August 26, 2019

Debbie Bickmire Planner II, City of Aurora 15151 E Alameda Pkwy, Aurora, CO 80012

In July, United Properties (UP) signed a lease with Tempur Sealy International (Tenant) at 18701 E. 38th Avenue for all of Building 1. The purpose of this Minor Site Plan Amendment application is to request exterior site plan modifications that are required for Tempur Sealy to operate in the existing building. These items include perimeter security fencing, conversion of 96 auto stalls into additional trailer parking, additional 15 dock doors in previously approved knock-out locations, and a concrete patio to allow for employees to enjoy outdoor space.

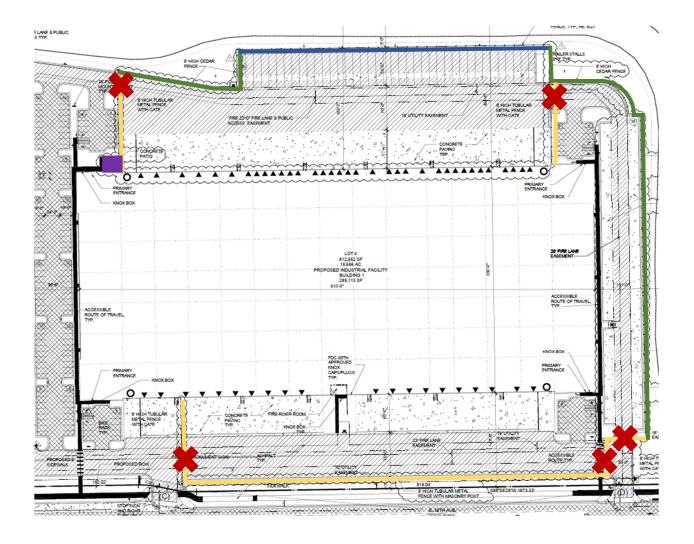
- 2. Revise Lot 4 site plan to:
 - a. Show the location(s) of all proposed fencing and gates.
 - i. All loading and trailer parking areas to be screened with opaque fence RESPONSE: All loading and trailer parking to be screened with 8' opaque cedar fencing.
 - ii. Fences shall be placed a minimum of 4' behind adjacent sidewalk (Section 146-1470(E))

iii. 18" x 18" Masonry columns required on 38th Ave. (Section 146-1743, Table 17.2). Columns shall be placed at all fence corners, transitions to other fence styles along a run of fence, and fence termination points.

c. Revised landscape plan to accommodate fence. Fence along 38th Avenue shall be located behind the required landscape buffer.

RESPONSE: The fence is 23' behind adjacent sidewalk.

RESPONSE: 20x20 masonry columns have been placed every 56' along 38th Avenue, including at fence corners, transitions to other fence styles. Fence termination points are against the building.

Below is a depiction of the fencing, additional trailer parking, and outdoor patio locations. Blue is previously approved 8' cedar fence for screening purposes. Green represents proposed new 8' cedar fencing. Yellow represents 8' ornamental iron security fence, and red "X" locations are the gate locations for vehicular access. The outdoor patio is shown in purple. This image is for illustrative purposes only, please see formal Site Plan submittal for exact locations and detail.
